Office Action Summary

10/812,890

JAPP ET AL.

DETAILED OFFICE ACTION

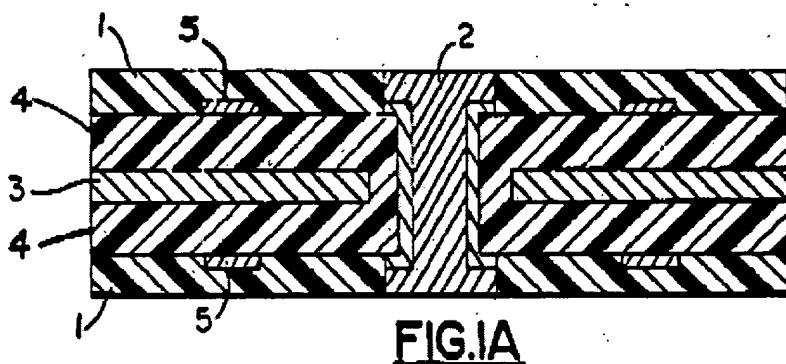
Bindra (fig 1A,the title, the abstract, column 2 line 13-25) discloses a circuitized substrate comprising: a first layer (fig 1 A, layer 4) comprised of a dielectric material including a resin material including a predetermined quantity of particles therein and not including continuous fibers, semi-continuous fibers or the like as part thereof; and at least one circuitized layer (layer 1 ,circuit 5 fig 1A) positioned on the first layer.

Noted that Bindra uses PTFE and CTFE organic resin compound with quartz or silicon particle filler and therefore, the dielectric does not contain fibers.

Bindra (column 2 line 19) discloses the use of quartz particles and quartz is silica.

Bindra (column 4 lines 15-25) discloses a circuitized layer (fig 1A layer 3) made of copper.

Bindra (fig 1A, layer 1, layer 4, layer 3) discloses a circuitized substrate further including a second circuitized layer positioned on the first layer on a side opposite the at least one circuitized layer.

Bindra (fig 1A,column 3 lines 66-68 ,column 4 lines 1-3) discloses a circuitized substrate that includes a plurality of conductive thru-holes (Bindra word for the conductive through hole is via) in the first layer, selected ones of the conductive thru holes electrically coupling selected parts of the at least one circuitized layer to selected parts of the second circuitized layer.

FIG. 1

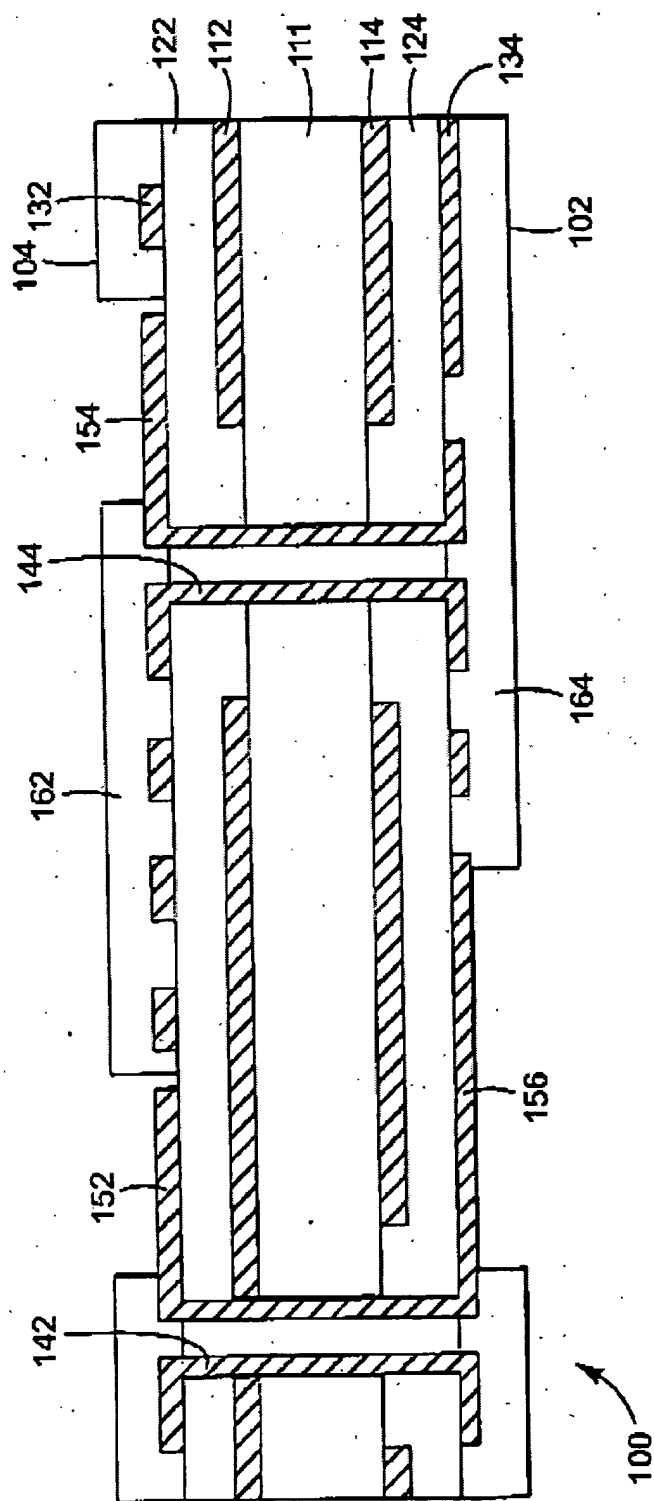
Mao discloses (in fig 1 in paragraph [0013]) a circuitized substrate comprising: a first layer comprised of a dielectric material including a resin material including a predetermined quantity of particles therein and not including continuous fibers, semi-continuous fibers or the like as part thereof; and at least one circuitized layer positioned on the first layer this circuitized substrate further including second and third dielectric layers positioned on the at least one

circuitized layer and the second circuitized layer, respectively, and third and fourth circuitized layers formed on the second and third dielectric layer, respectively.

Noted that Mao discloses a circuitized substrate that has 3 dielectric layers with layers 124, 111 and 122 correspond to the first, second, and third dielectric layers and layers 134, 114, 112, and 132 correspond to the first, second, third, and fourth circuitized layers.

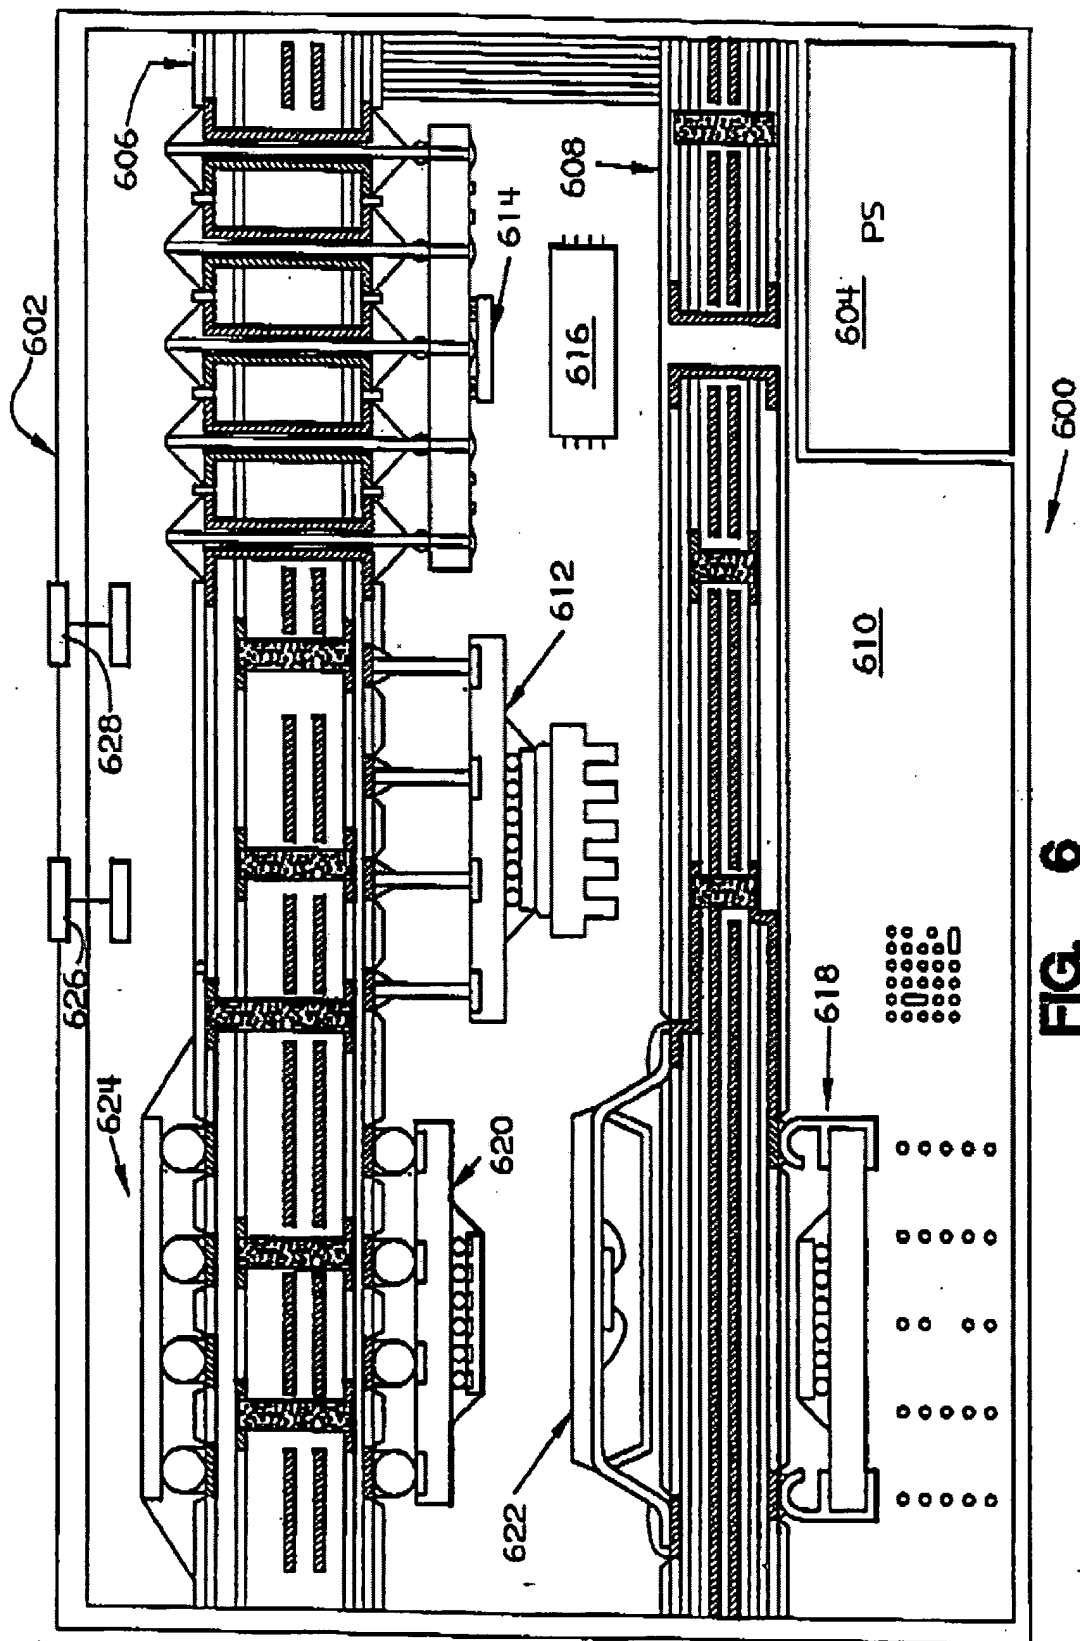
Bindra (fig 1A) discloses all the invention except for the relative size of the through holes in respect with the thickness of the substrate, the size of the filler particles and the percent of the content of the particles filler for the substrate. These limitations, however, are considered obvious since it has been held that when the general conditions of a claim is disclosed in the prior art discovering the optimum value or workable range is within the ordinary routine skill of an ordinary artisan in the art.

A person skilled in the art at the time the invention was made would be able to derive from the teachings by Bindra and his own routine design skill and come up with the inventions of claim 2,4,10 for the purpose of improving the device invented by Bindra.

Bindra (fig 1A) discloses all the invention except is silent about putting on the circuitized substrate a chip carrier. This limitation, however, is considered obvious since the use of chip carrier on a circuitized substrate is old and well known in the art as evidence by the disclosure by Bhatt et al. (US patent 5,822,856) fig 6, chip carriers 612,614,620.
